Planning & Development Division
Planning & Economic Development Department

File Number	PLPR-2505-0002		Contact	Jason Mozol, jmozol@duluthmn.gov	
Type	MU-I Planning Review		Planning Commission Date		June 10, 2025
Deadline for Action	Application Date		May 23, 2025	60 Days	July 22, 2025
	Date Extension Letter Mailed		May 27, 2025	120 Days	September 20, 2025
Location of Subject		2030 N Arlington Ave			
Applicant	St Louis County		Contact	Scott Hudson	
Agent	Widseth		Contact	Ryan Erspamer	
Legal Description		010-2710-03940			
Site Visit Date		May 29, 2025	Sign Notice Date		May 25, 2025
Neighbor Letter Date		May 23, 2025	Number of Letters Sent		93

The applicant is proposing a ~12,000 square foot cold storage building at 2030 N Arlington Ave in an MU-I district.

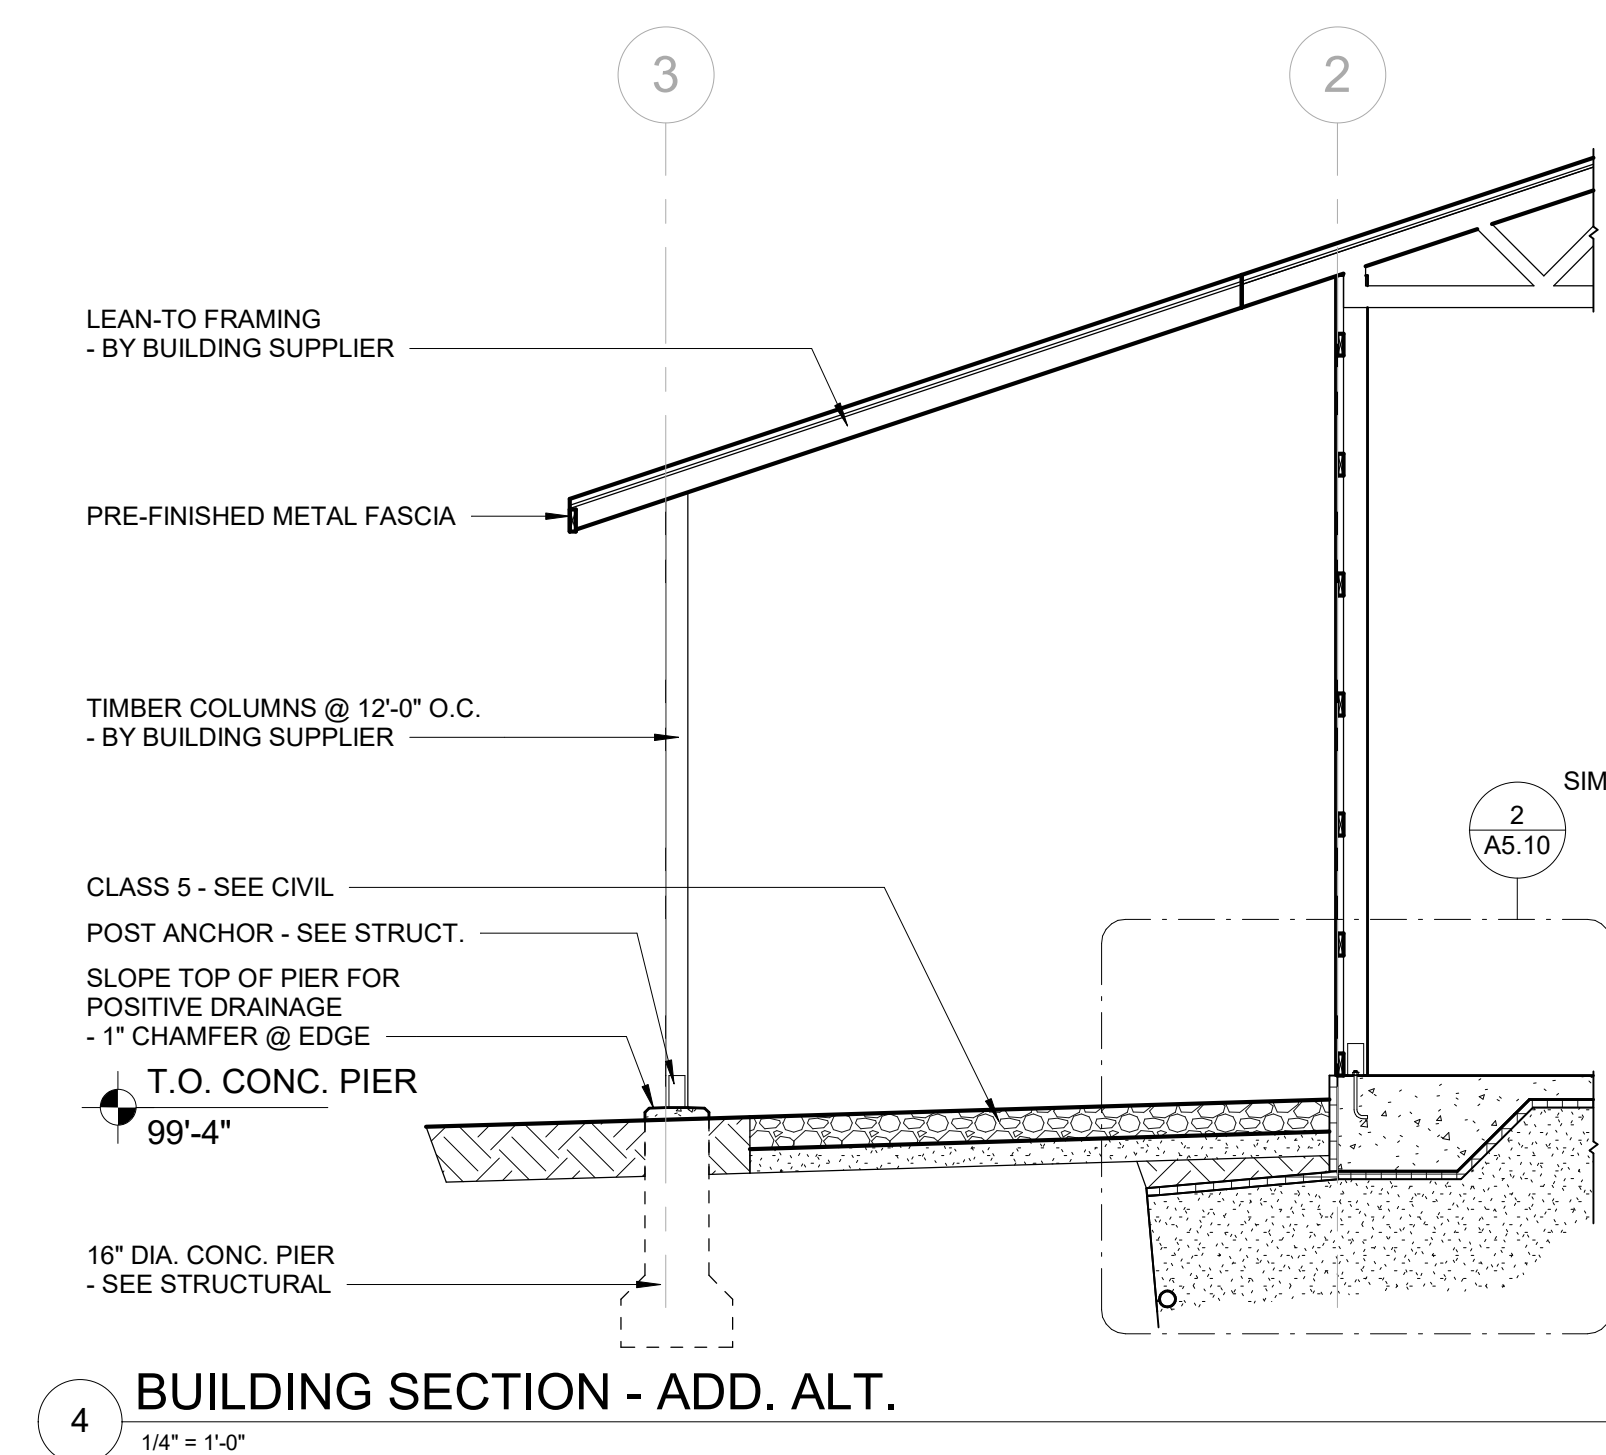
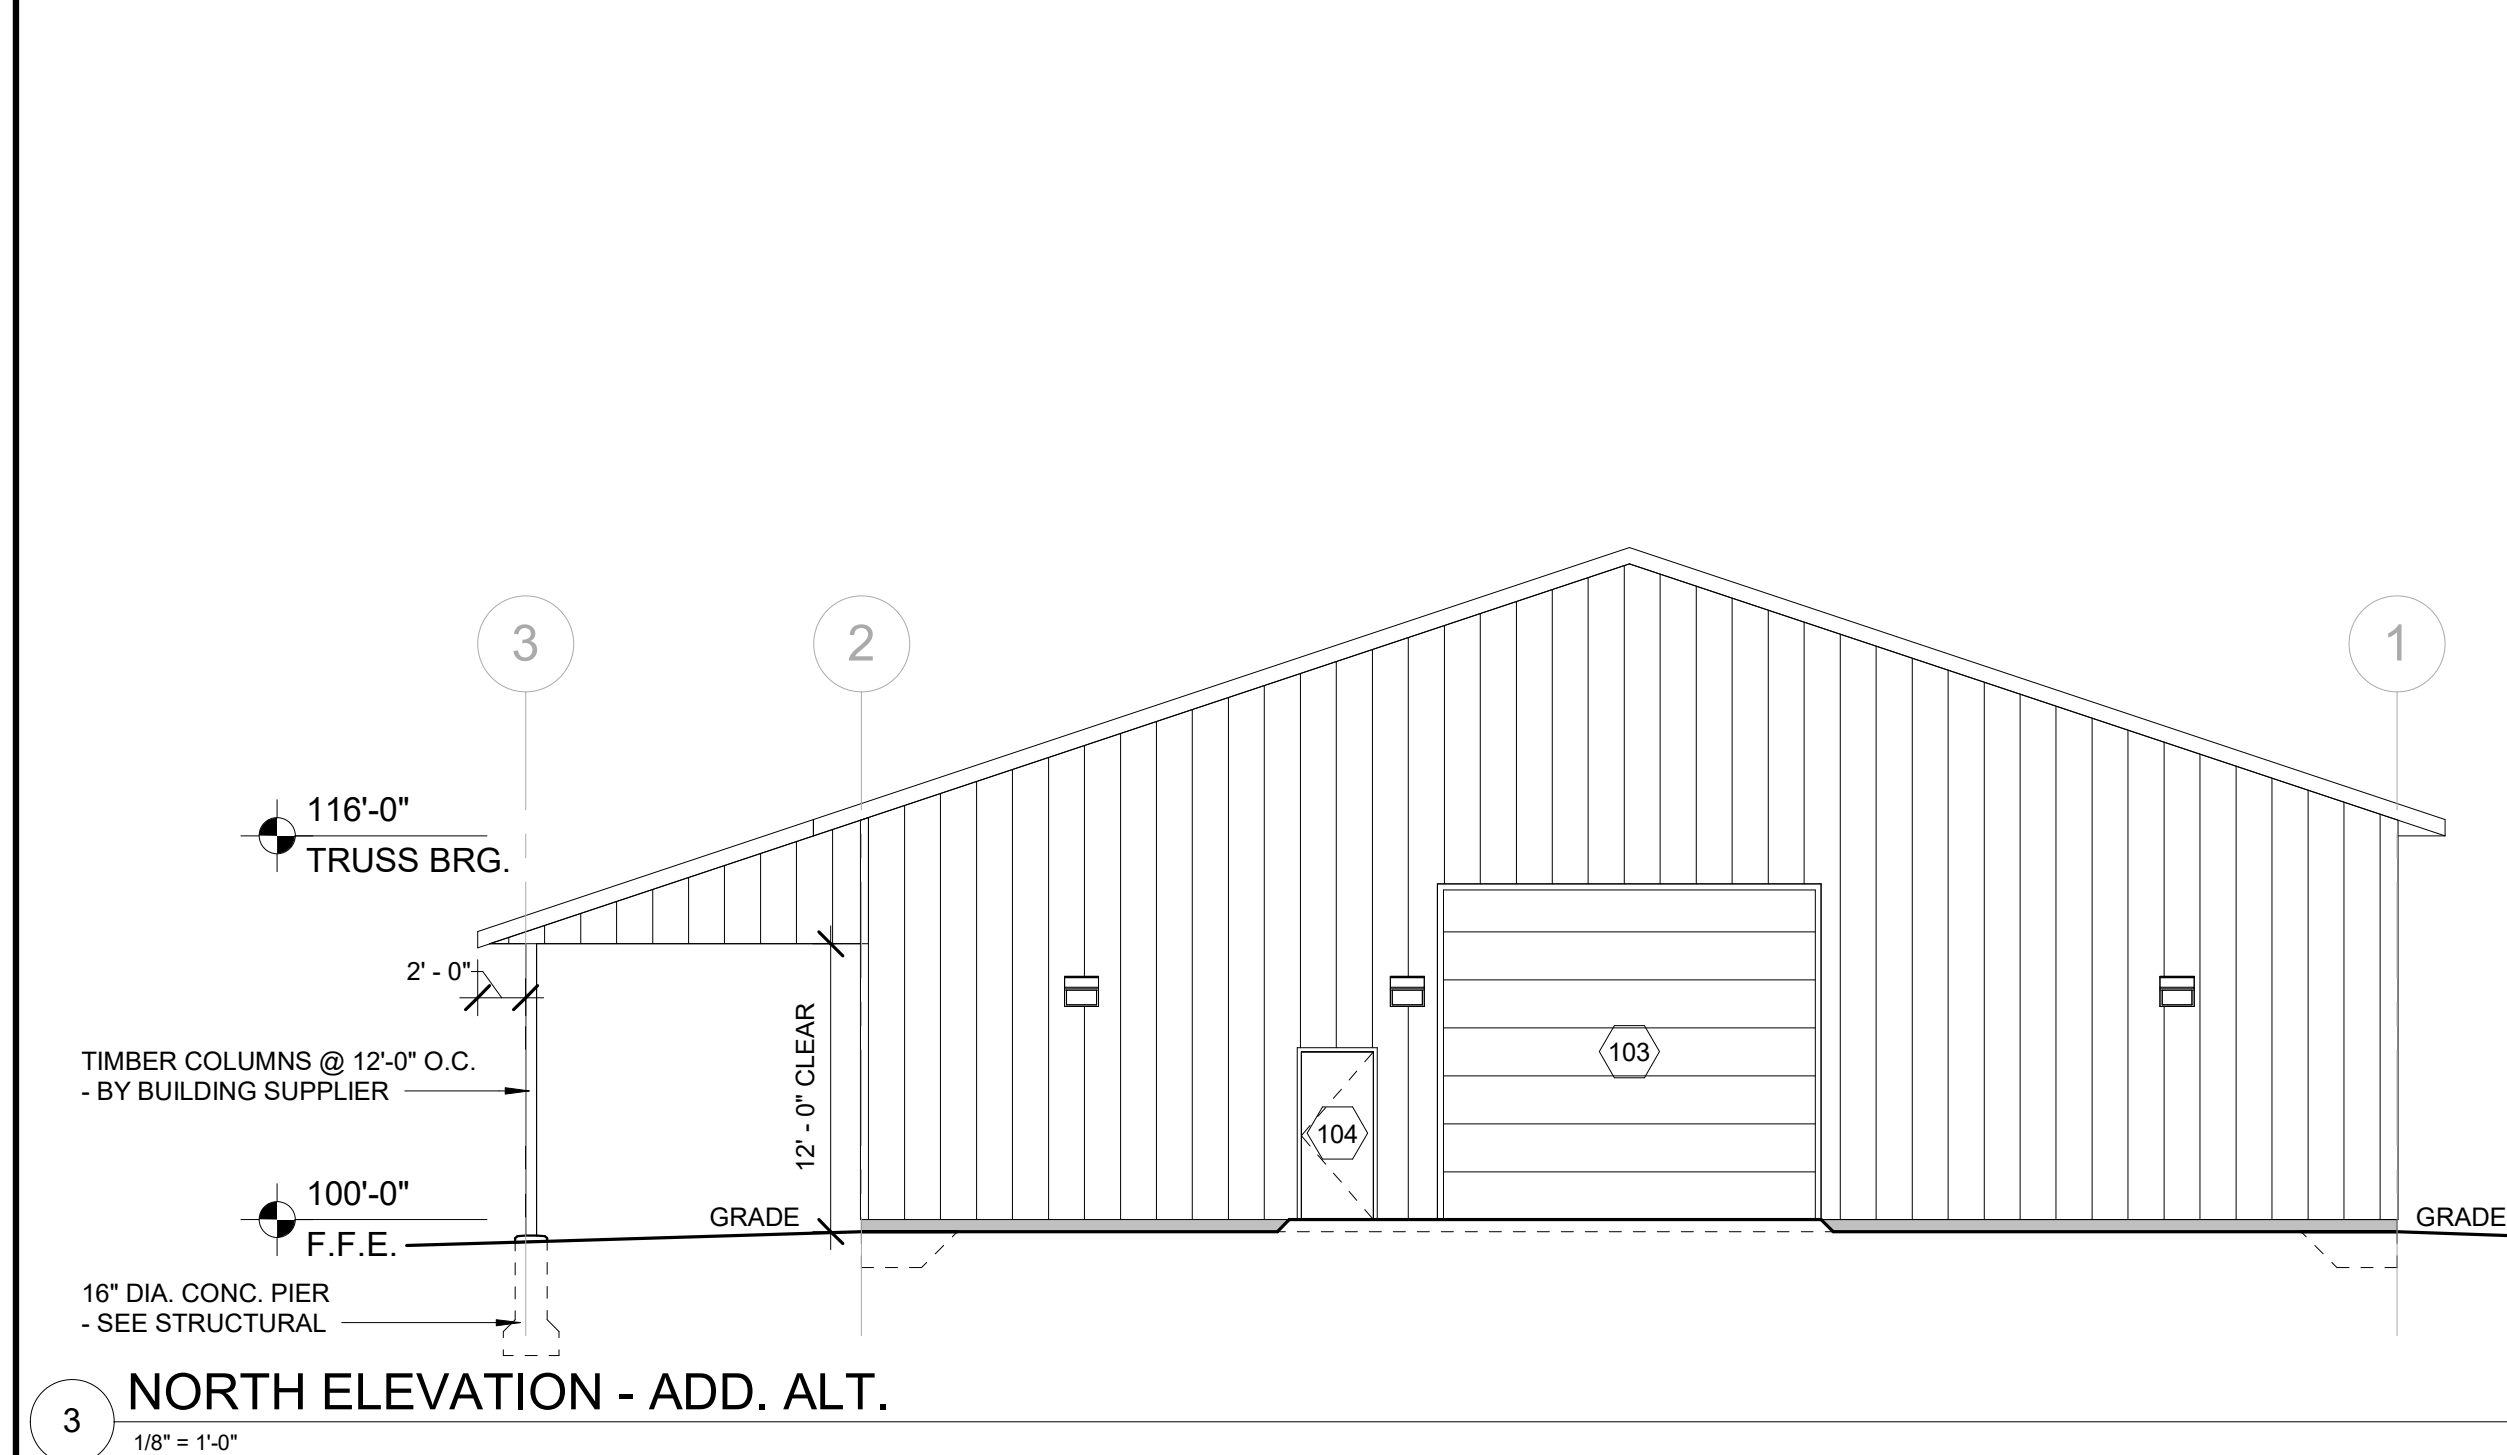
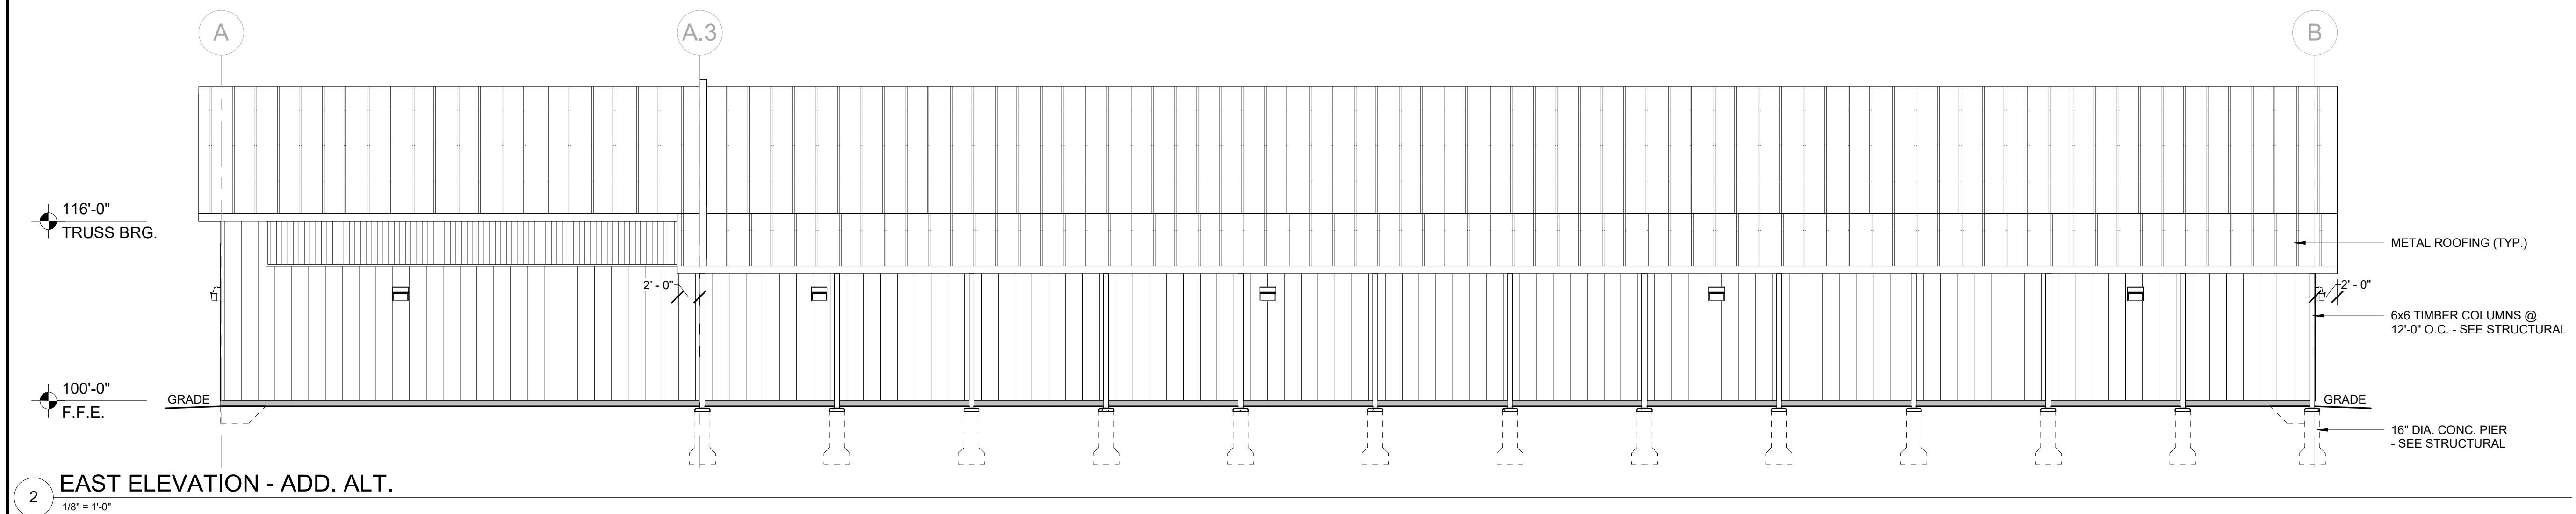
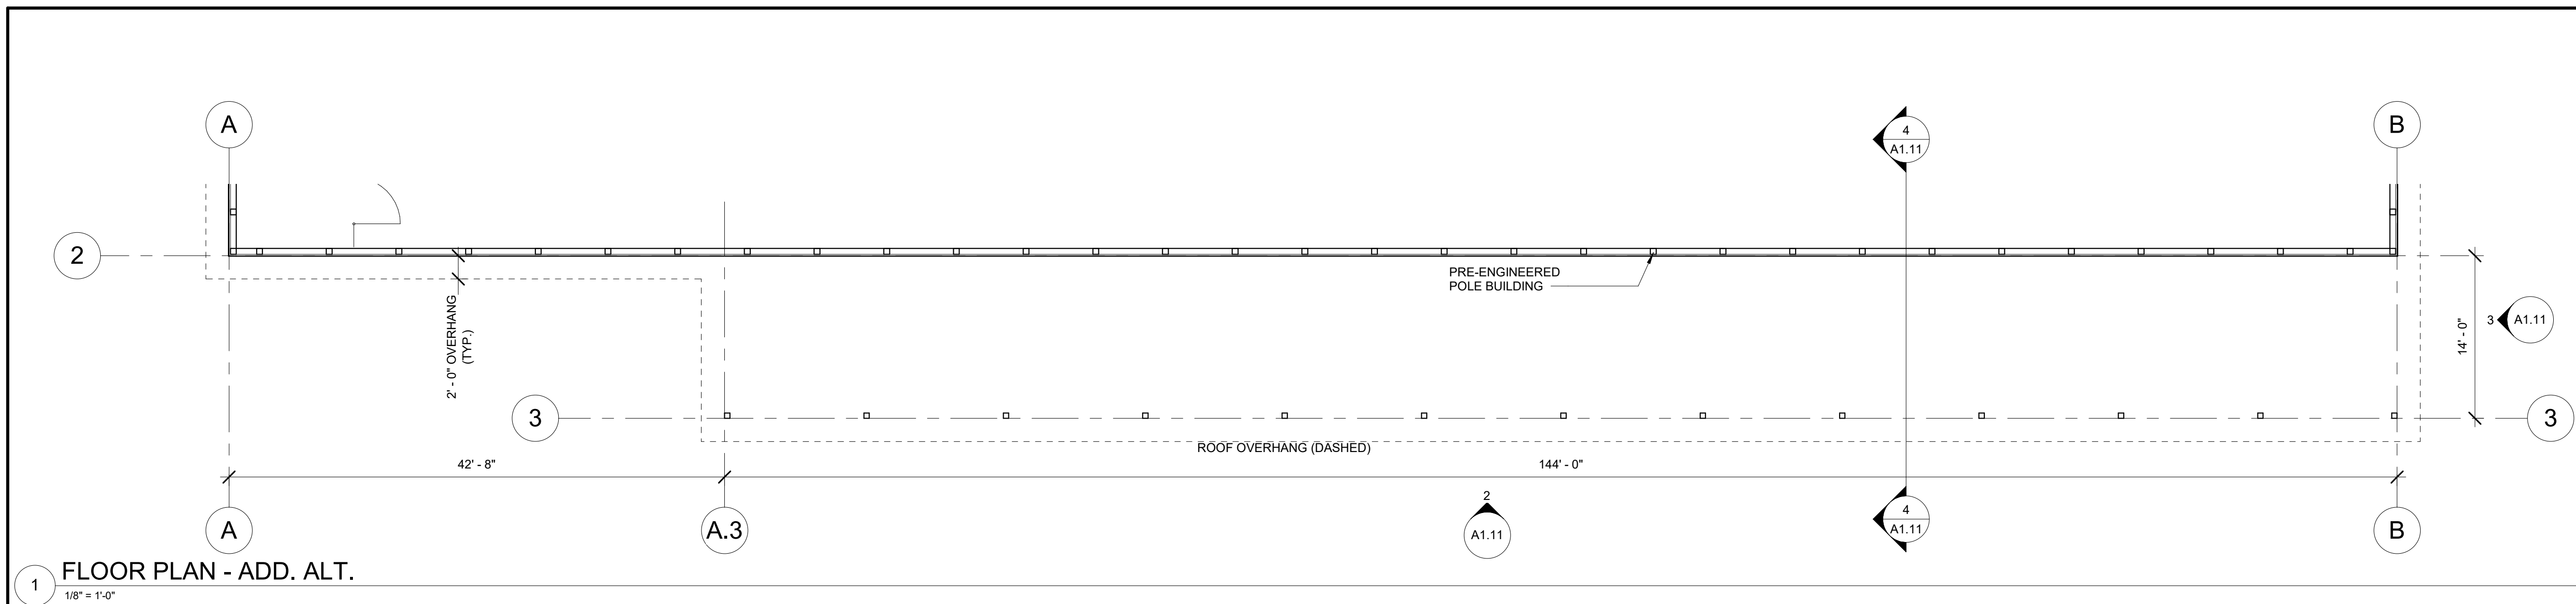
8. Sec. 50-31 (Exterior Lighting). Exterior lights will be installed on the outside of the structure. The applicant provided a photometric plan and light fixture designs. The proposed lighting exceeds the maximum illumination of 10 footcandles and the proposed fixtures do not meet the downcast or cutoff requirements. A compliant lighting plan must be submitted to the Land Use Supervisor prior to building permit approval.

1. Applicant shall construct and maintain the project as identified in the attached exhibits.
2. An amended, compliant lighting plan be submitted and approved by the Land Use Supervisor prior to building permit approval.
3. Any alterations to the approved plans that do not alter major elements of the plan may be approved by the Land Use Supervisor without further Planning Commission approval; however, no such administrative approval shall constitute a variance from the provisions of Chapter 50.
